August 28, 2014
NND-14-0471
10 CFR 50.90

Virgil C. Summer Nuclear Station (VCSNS) Units 2 and 3
Combined License Nos. NPF-93 and NPF-94
Docket Nos. 52-027 & 52-028

Subject: LAR 13-23 R2 Reinforced Concrete to Steel Plate Composite Construction
Connections

UFSAR Subsection 3H, Figure 3H.5-7 - Revise information as shown in the revised figure on the following pages.

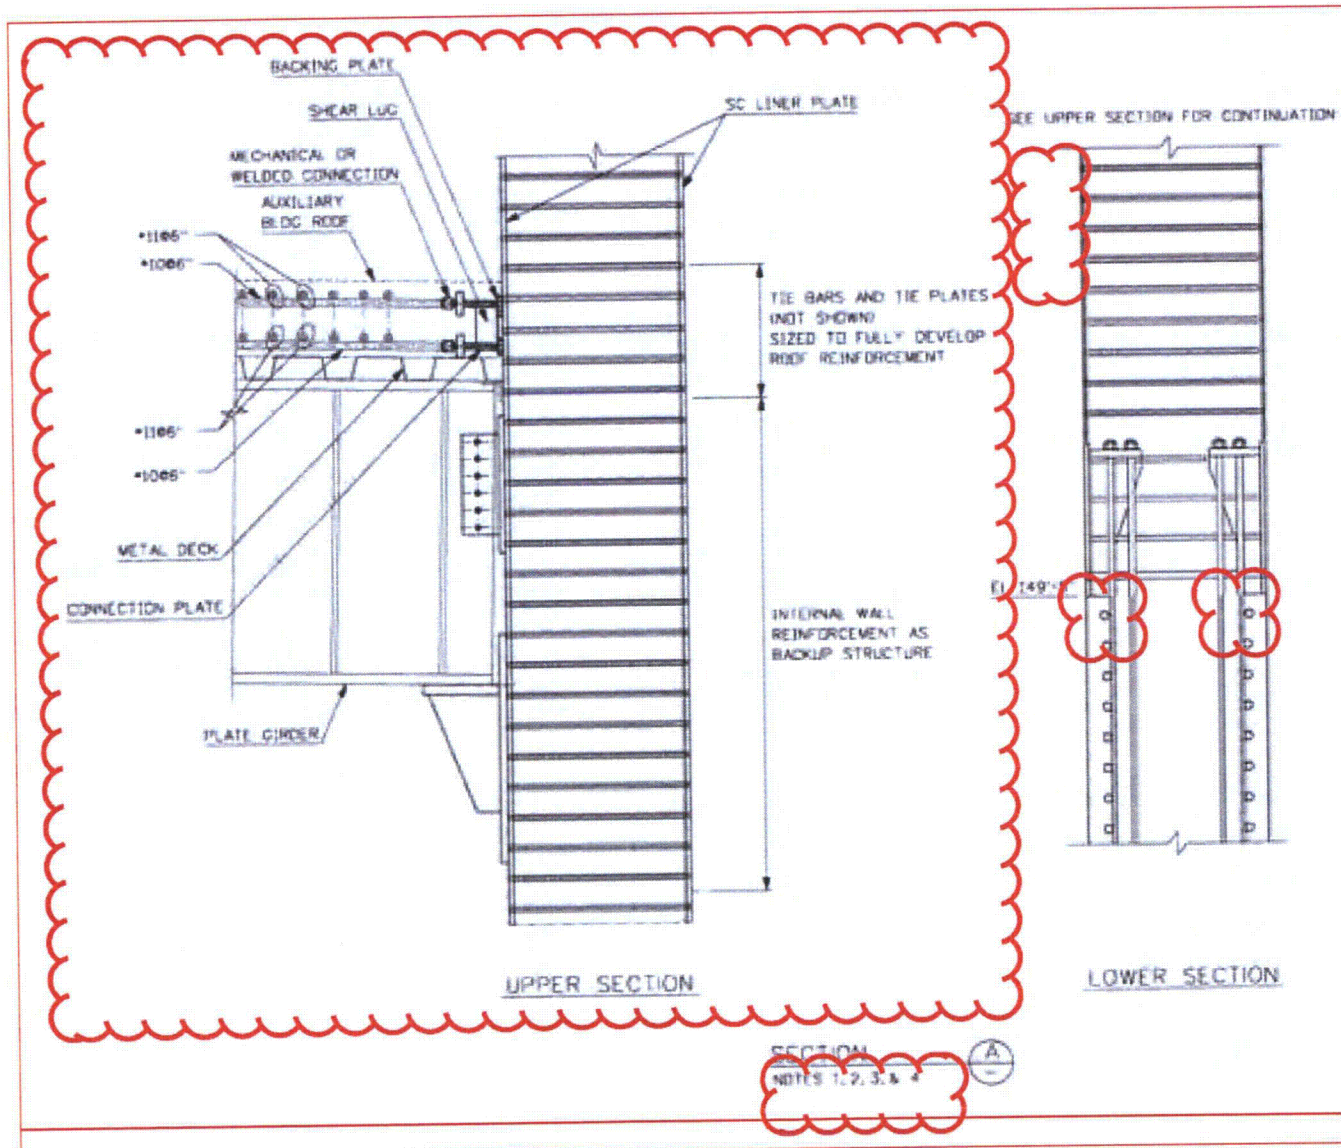
Revise the information in UFSAR Figure 3H.5-7 as follows:

1. The Upper Section in the Section A detail showing an elevation of the roof to wall module connection information is revised to reflect changes to the connection of the roof to the wall including change in the design of the shear lug, addition of a connection plate for connection of roof reinforcement to structural modules, the addition of a stiffener plate, the addition of an connecting plate welded to the module faceplate, and the change in the design of the connection of the girder to the wall. The extension of roof reinforcement into the wall is removed and tie bars in the wall module are designated as internal wall reinforcement to develop roof reinforcement and provide backup structure for the roof girder connection.

2. Extraneous information is removed from the roof plan including the shield building wall radius and thickness, dimensions of the roof and walls, column lines not needed to define the critical section, distance between column lines, roof elevations, and center lines and the information removed from UFSAR Figure 3H.5-7 is provided in UFSAR Figure 3.7.2-12 and Subsection 3H.5.2.2. The representation of the roof reinforcement requirement is changed to not extend into the wall. The N (North) direction indicator is removed from the upper right portion of the figure.

3. The partial PLAN AT EL. 170'-0" which shows the connections between auxiliary building Wall 4 and Wall N and the shield building wall is revised. The information revised is the detail design of the connection of auxiliary building walls to the shield building wall, and these connections are not included in the critical section addressed in UFSAR Subsection 3H.5.2.1 and this figure.

4. The drawing scale is removed from the Roof Plan because UFSAR figures are not to scale. The scale is not relevant to the critical section addressed in UFSAR Subsection 3H.5.2.1 and this figure and UFSAR figures are not to scale.

5. The REINFORCEMENT FLOOR DETAIL IN REGION "A" information is removed since the information is provided in other UFSAR figures including Figure 3H.5-6. The size and spacing of the reinforcement bars are shown in the Roof Plan of Figure 3H.5-7. The dimensions of the metal decking and the roof thickness are included in Figure 3H.5-6.

6. The REINFORCEMENT FLOOR DETAIL IN REGION "B" is removed since it is duplicate information to the Tier 2* information details shown in SECTION A.
7. The tie bar spacing is removed from the Lower Section in Section A. This information is available in APP-GW-GLR-602, Figure 6.

8. Couplers are removed from the vertical bars in the Lower Section of Section A to reflect changes in the detail design.
9. The following notes are added.

**Figure 7, Typical Auxiliary building RC roof connection to the shield building SC wall -
Revise the figure as shown below.**

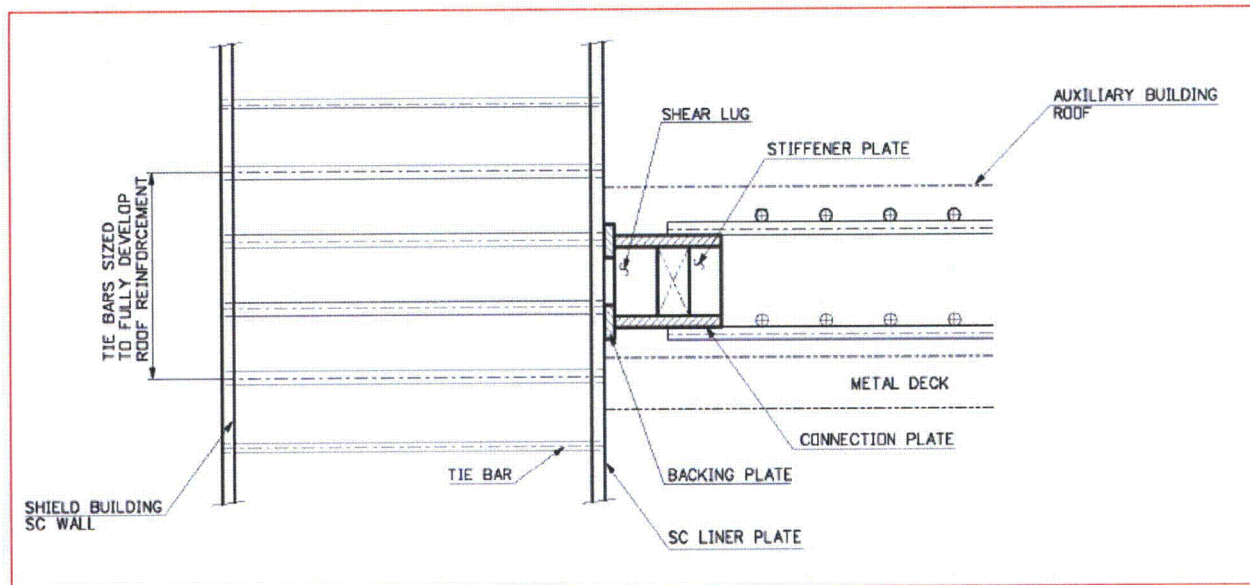
Revise Figure 7 to show a revised connection design including:

7. Revise Note 1 to remove the specific size and spacing of reinforcement inside the wall and add the requirement to fully develop reinforcement in the roof.

8. Revise Note 2 to include discussion of load path through connection plates and tie bars.
9. Revise Note 2 to identify that the details of the connection design may vary.

10. Remove Note 5 and move information on couplers to Subsection 3.8.4.5.5.6.
11. Add note to reference Subsection 3.8.4.5.5.6 for supplemental design requirements.
